STAFF RECOMMENDATION
133 Bowling Avenue
November 20, 2019

Application: Partial Demolition; New Construction—Outbuildings
District: Richland-West End Neighborhood Conservation Zoning Overlay
Council District: 24
Base Zoning: R7.5
Map and Parcel Number: 10409013800
Applicant: Robert Stewart, owner
Project Lead: Melissa Baldock, melissa.baldock@nashville.gov

Figure 3 is the 1931 Sanborn map which shows a two-story dwelling with an automobile garage on the first floor.

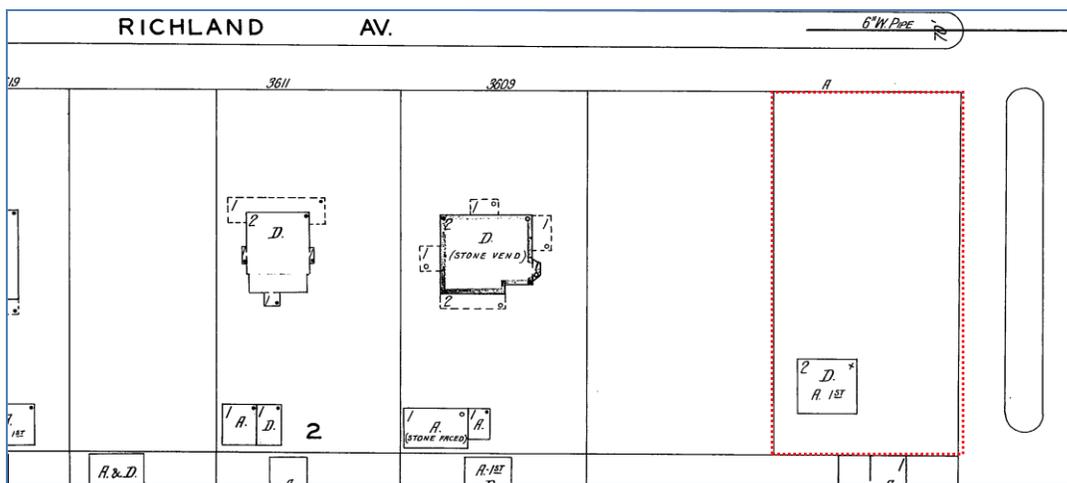
133 Bowling Avenue first appears in the City Directory in 1931. A Sanborn map from that same year shows the larger lot with the structure at 133 Bowling in the back corner of the lot (Figure 3). The Sanborn map conveys that the structure was a two-story structure, with a dwelling and automobile storage on the ground floor. It is the only structure on the lot at that time.

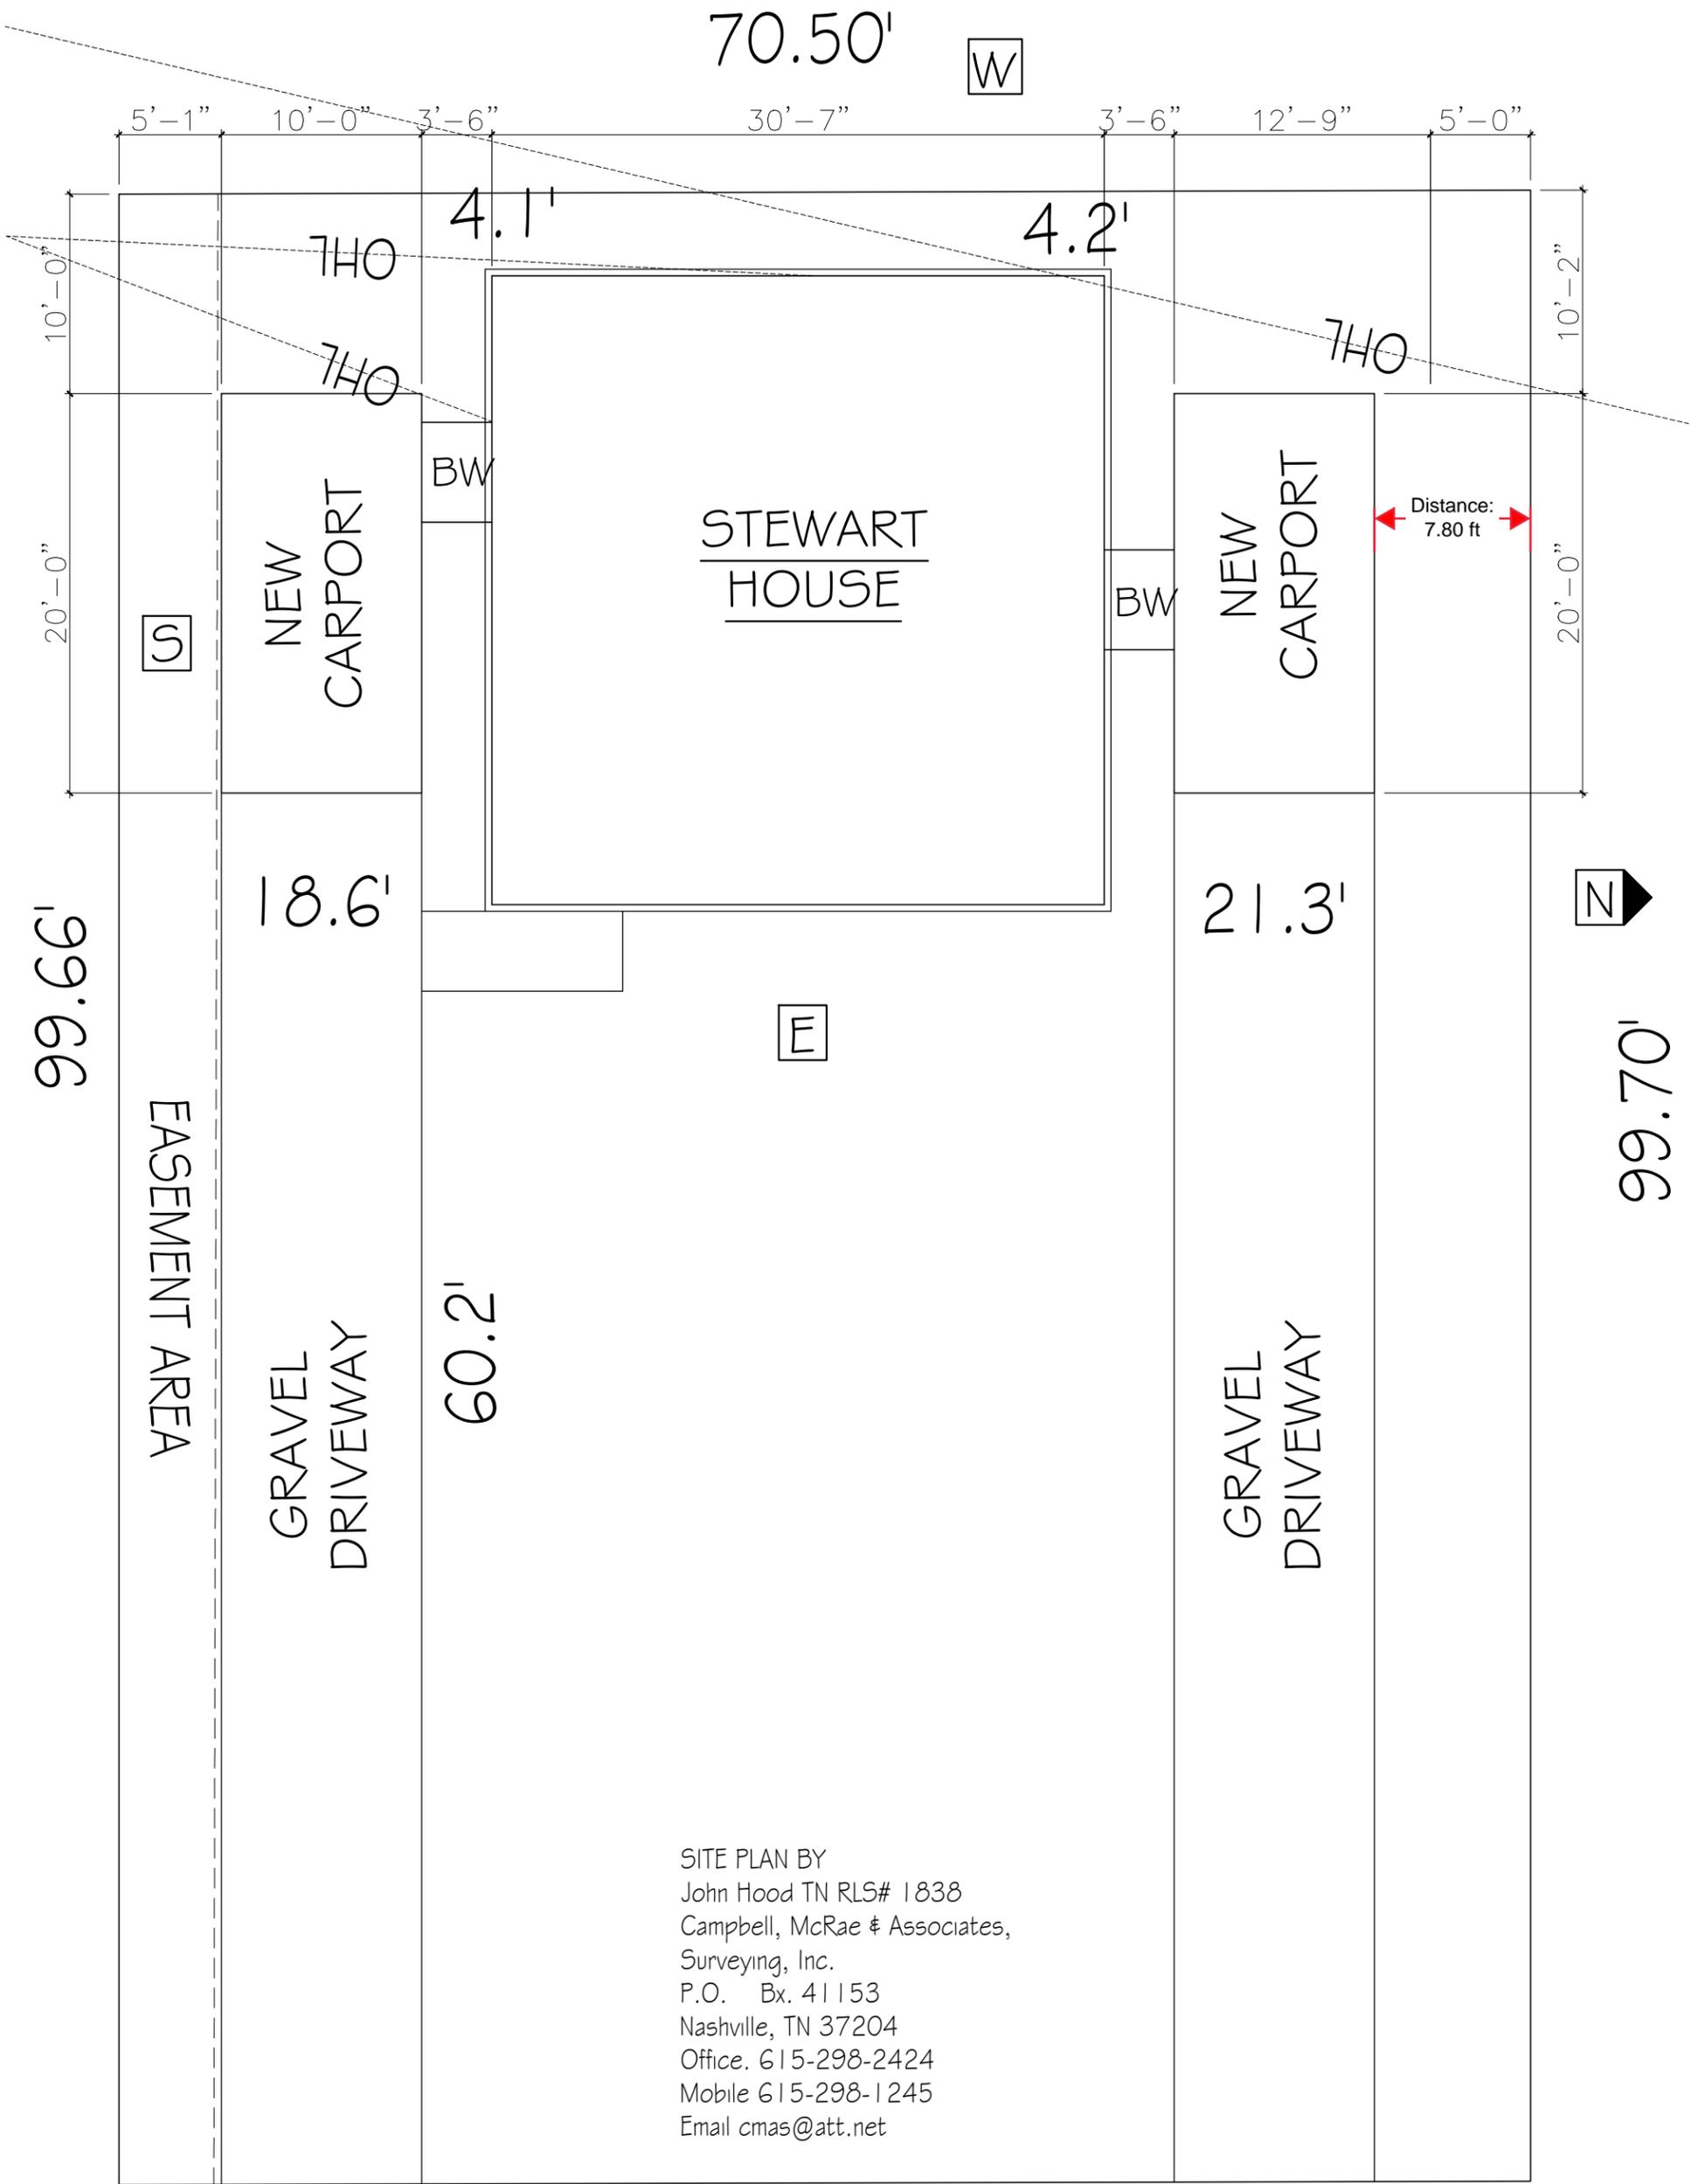
With the final approval the roof shingle color and texture and the driveway material, staff finds that the proposed materials meet the design guidelines.

Staff finds that the outbuilding’s location, height, scale, setbacks, roof form, and known materials meet Section II.B.1.c., II.B.1.d., and II.B.1.h. of the design guidelines.

1. Staff approve the material of the panel below the window on the historic house;
2. Staff approve the roof shingle color, dimension, and texture; and
3. Staff approve the material of the driveways.

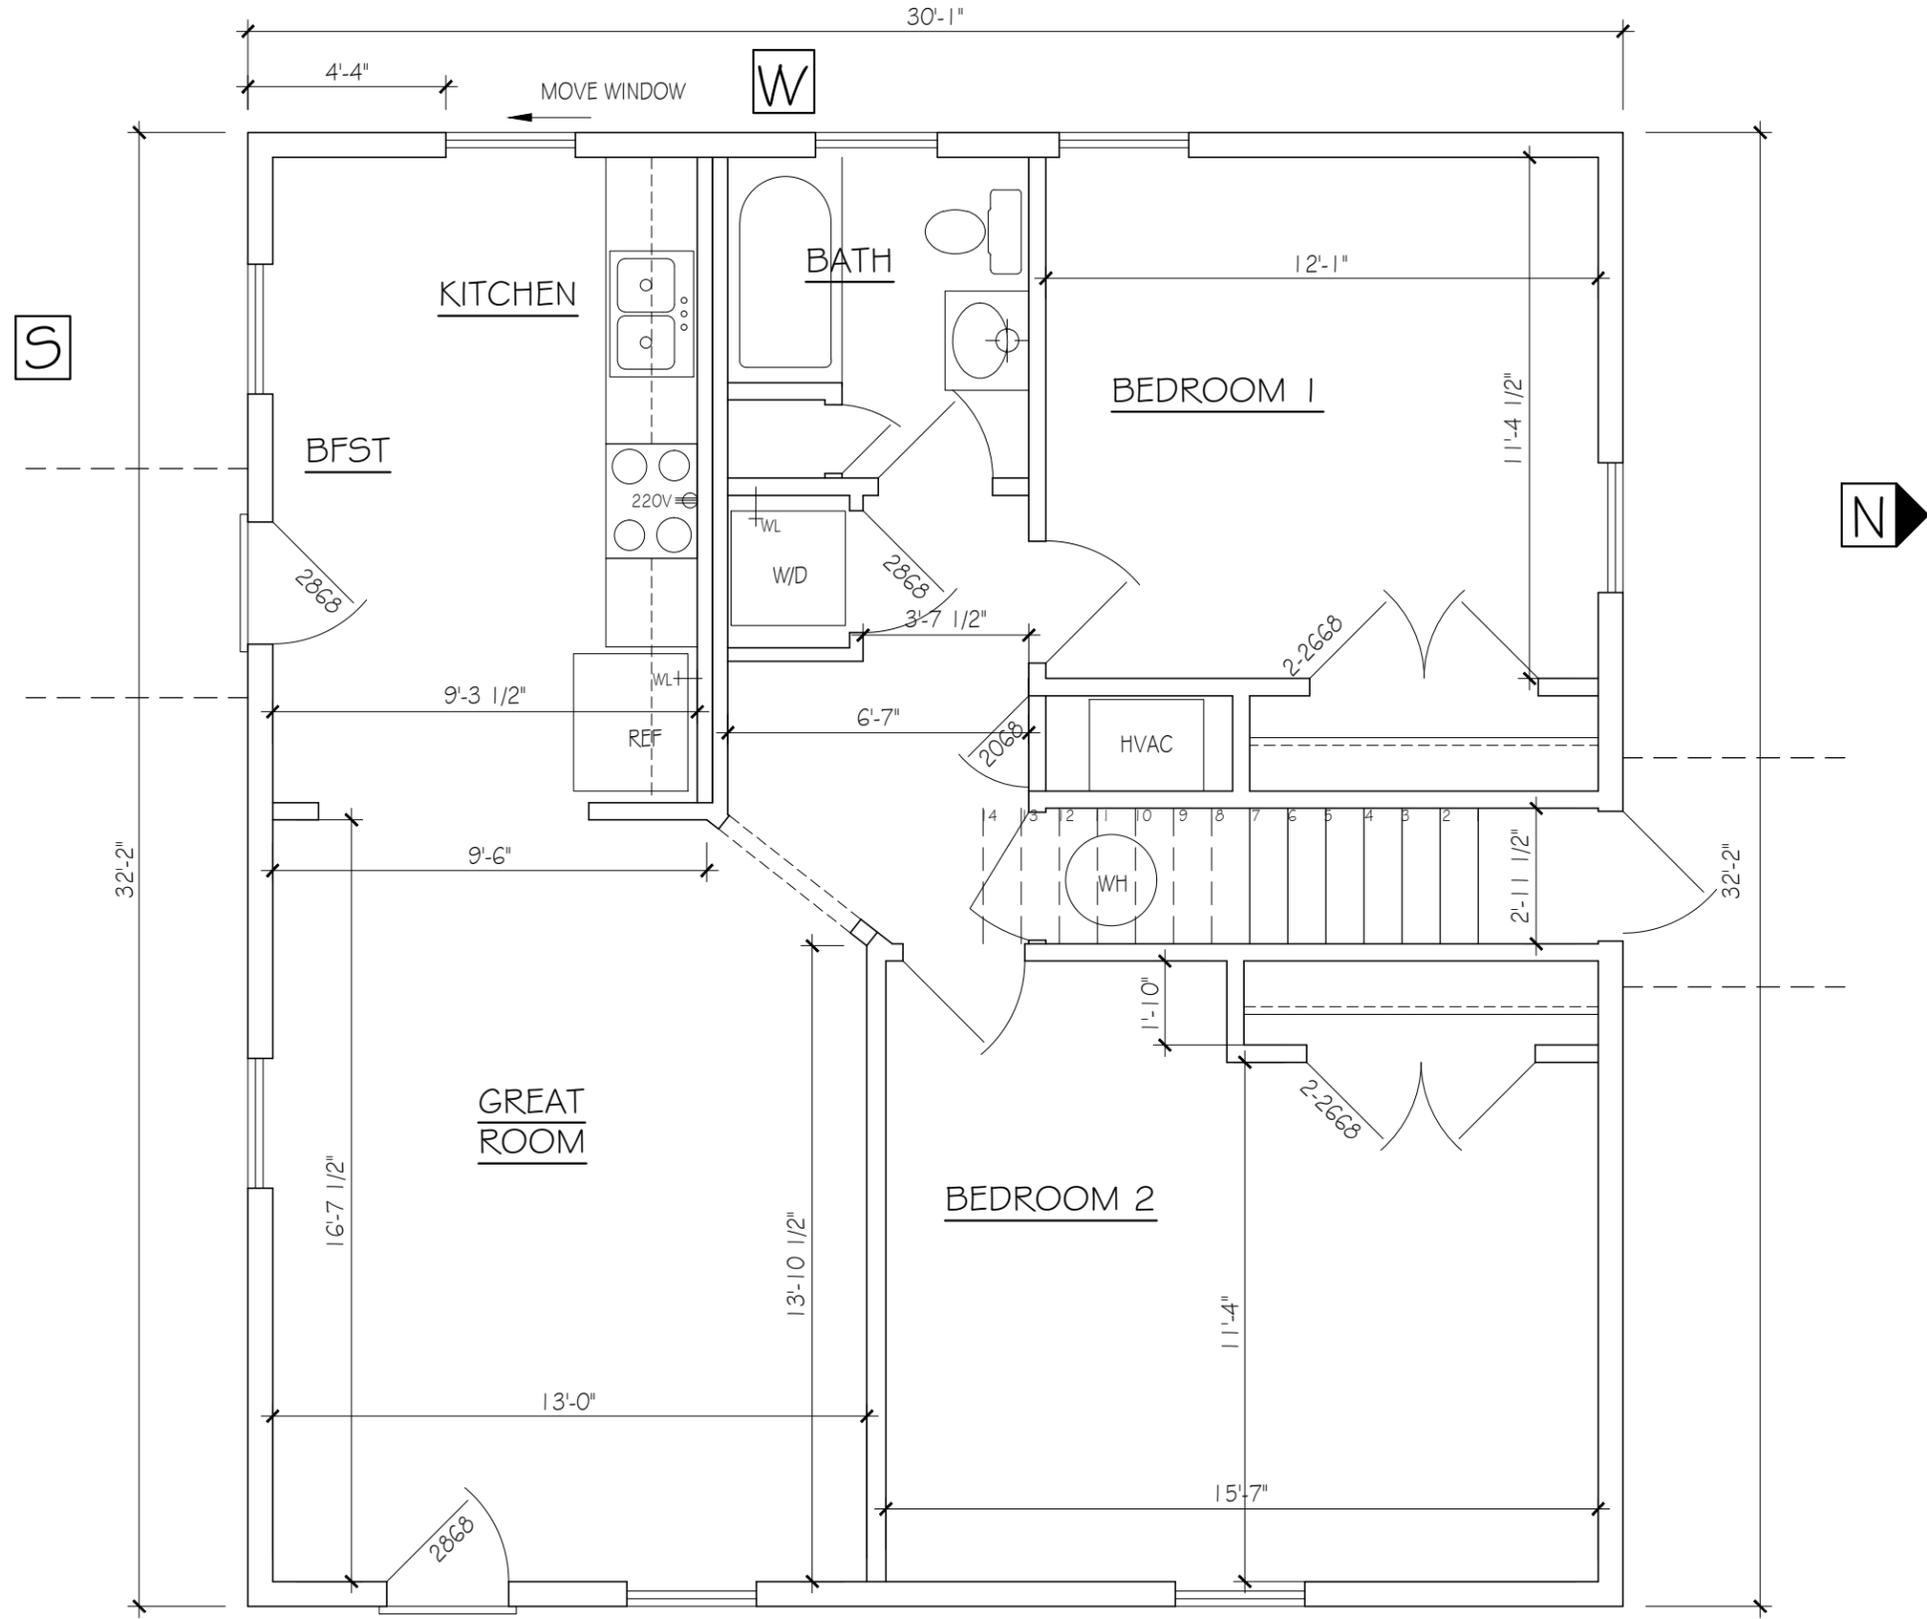
Outbuildings: The applicant is proposing two, ten feet by twenty feet (10' X 20') carports on either side of the historic house.

* Because of the historic house’s location at the back of the lot, lacking a rear yard, the carports are located to the side of the historic house rather to the rear. There is no way to locate the carports behind the historic house. The applicant has situated the carports as being just three feet, six inches (3’6’’) from the house, allowing the carport on the left side to meet the five foot (5’) easement on that side and allowing a symmetrical look for the right side carport. Staff finds this to be appropriate. The carports will be connected to the historic house with a four foot (4’) wide covered walkway; the Commission has approved such covered walkways in the past.

** 133 Bowling has two existing curb cuts and driveways, and the applicant plans to retain these two curb cuts and driveways, each leading to a separate carport (Figure 6).

Staff finds this to be appropriate, as the two curb cuts are existing. Also, if only one curb cut is used, then a driveway will have to cross in front of the existing house to reach the carport on the other side.
